DEPARTMENT of ENVIRONMENT
and NATURAL RESOURCES

The Air Quality Program has completed the review of the Basin NextGen draft Ambient Monitoring Plan. Enclosed in Attachment 1 and 2 are the department's comments and some additional information for the plan.

Attachment 1
Basin NextGen Air Monitoring Plan
Department of Environment and Natural Resources Review
January 25, 2007

Wind Rose Charts

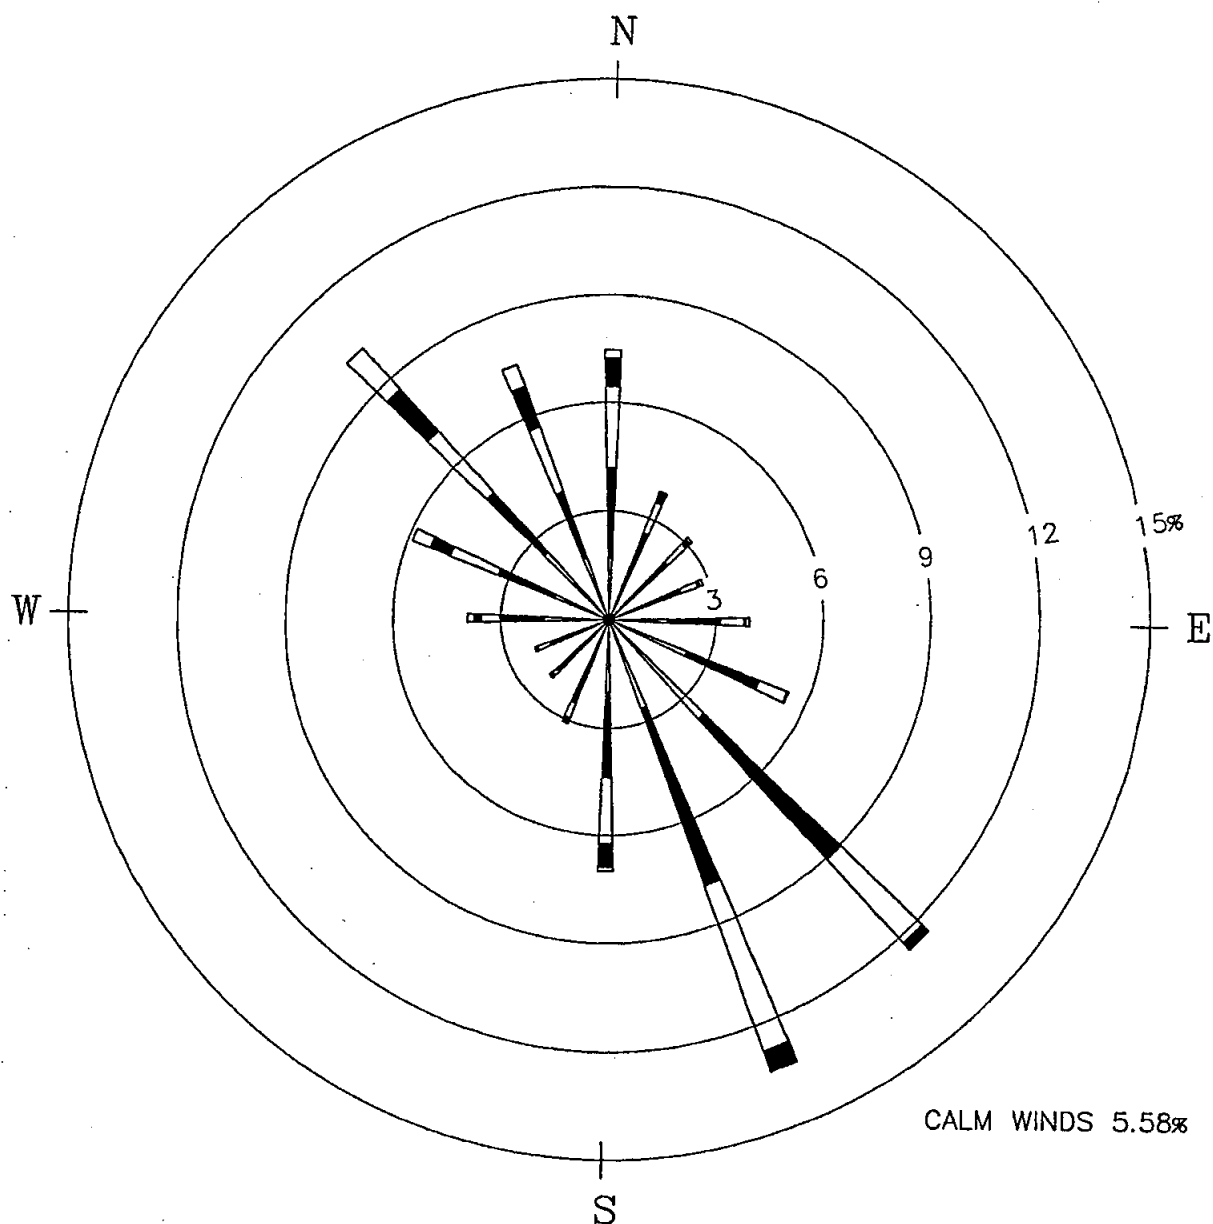
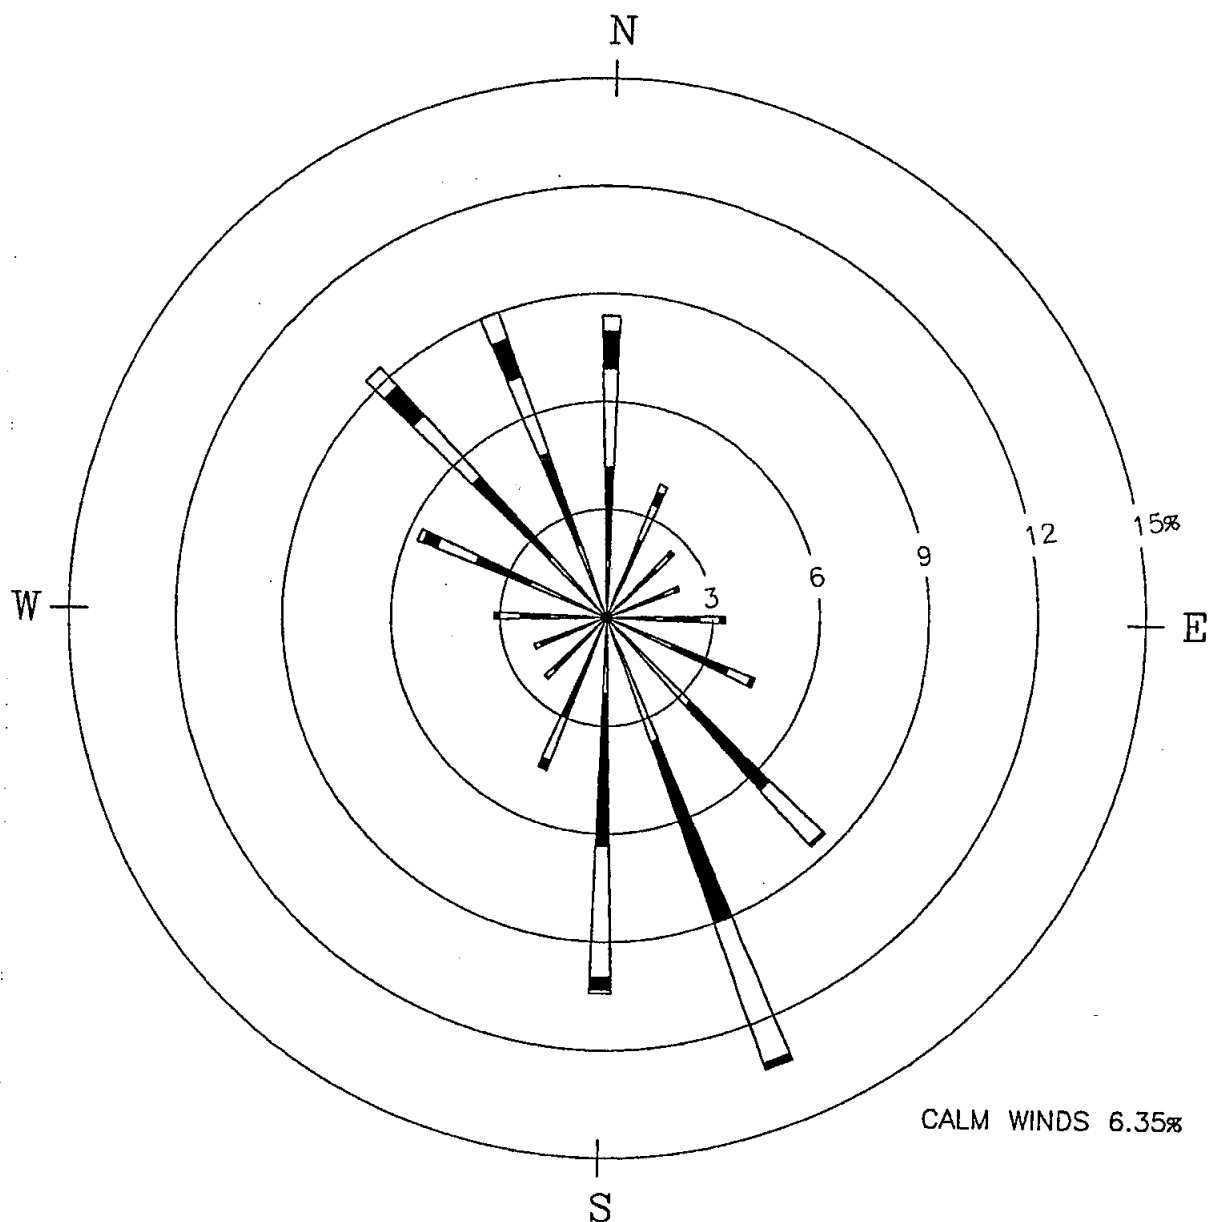
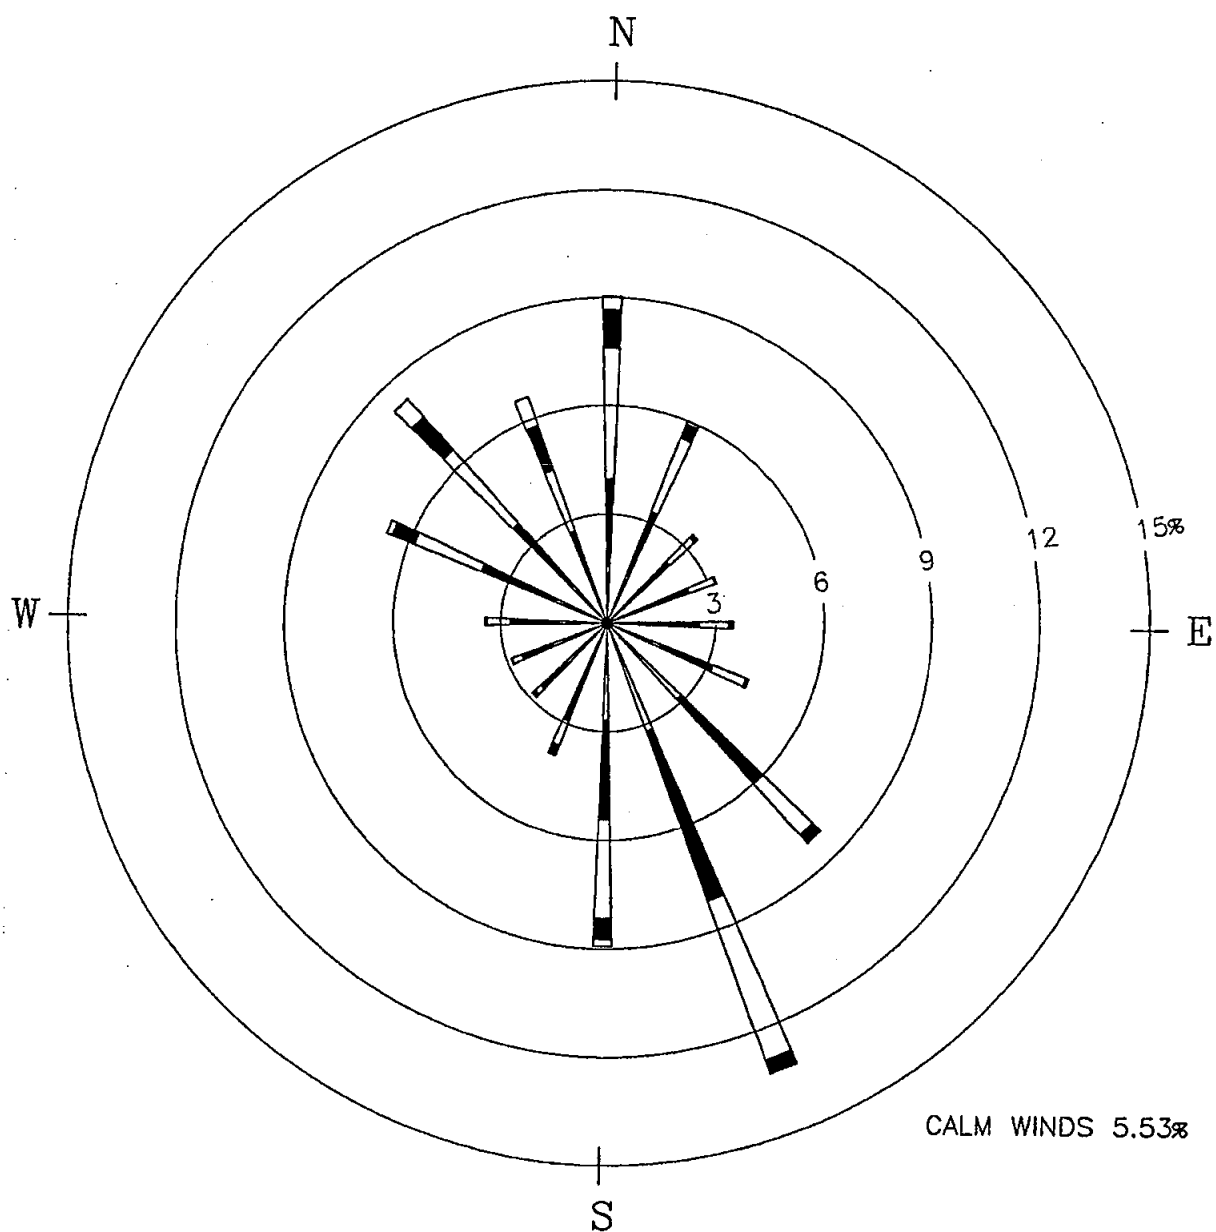
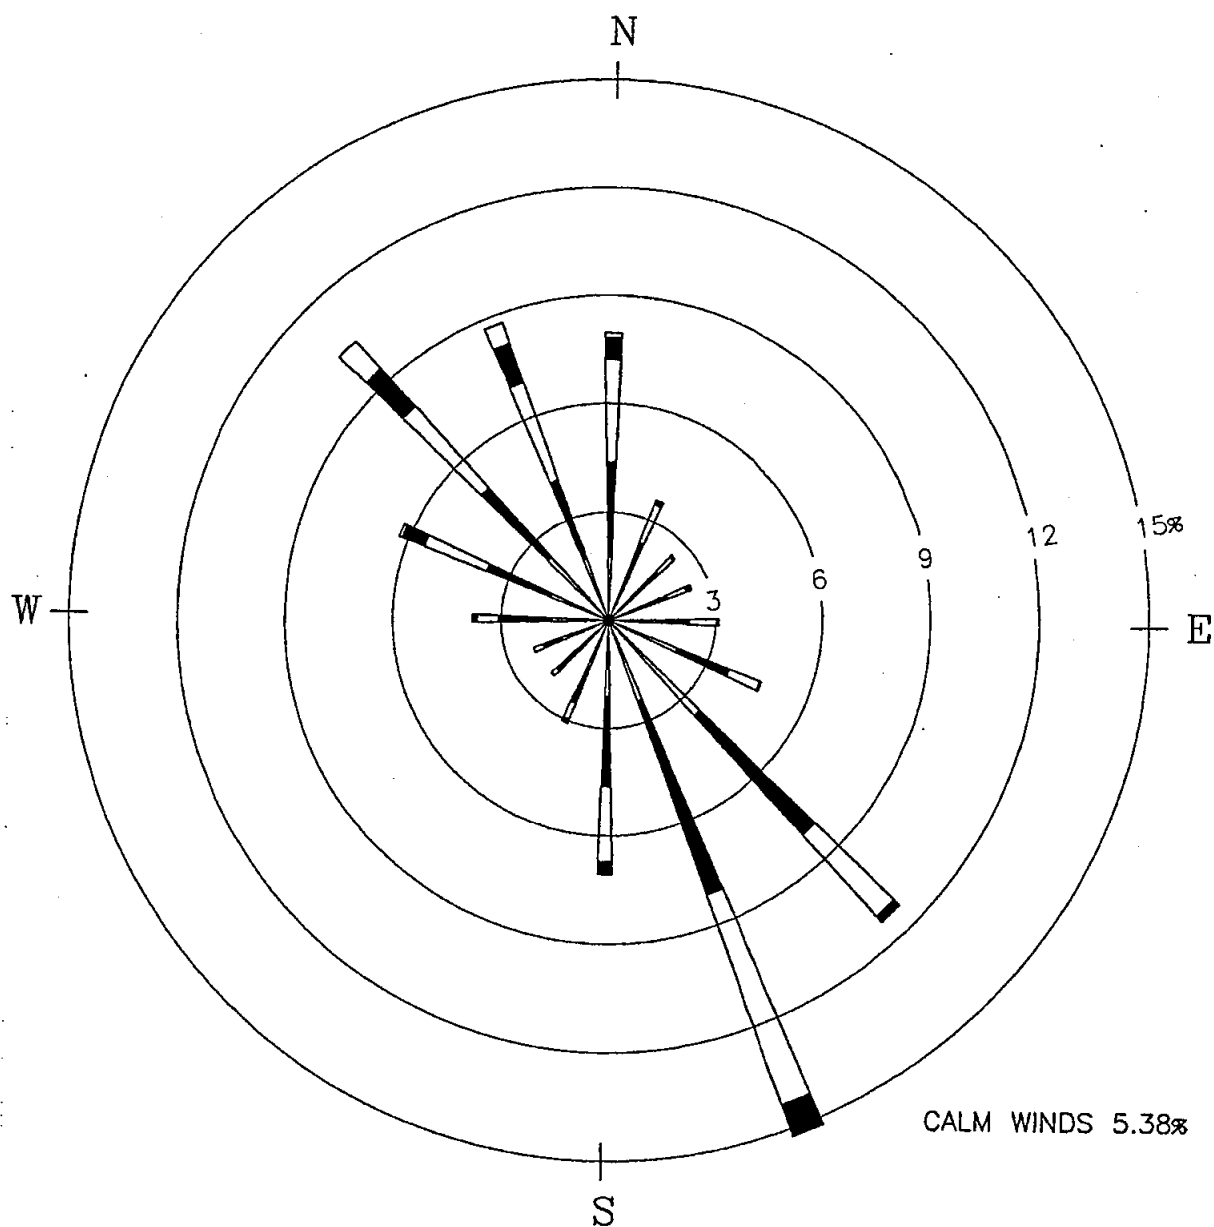
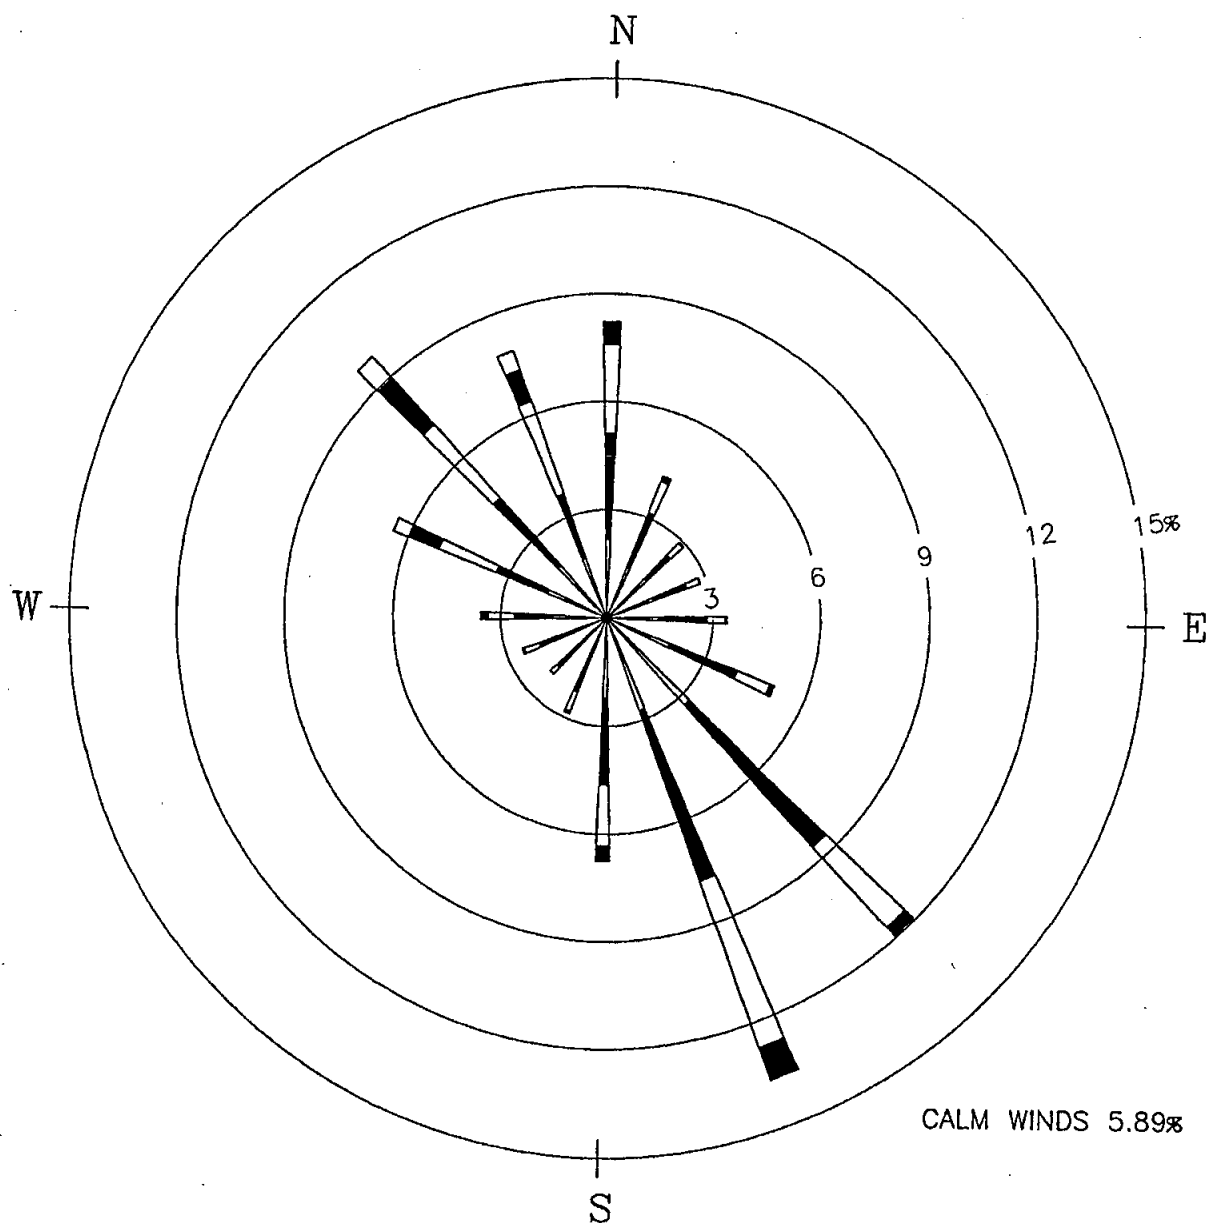
- Fourth paragraph in 2.2 Climate section: Seasonal wind directions in South Dakota are generally out of the northwest in the winter and southeast in the summer. See the attached wind rose showing the data from the Huron Airport weather station.
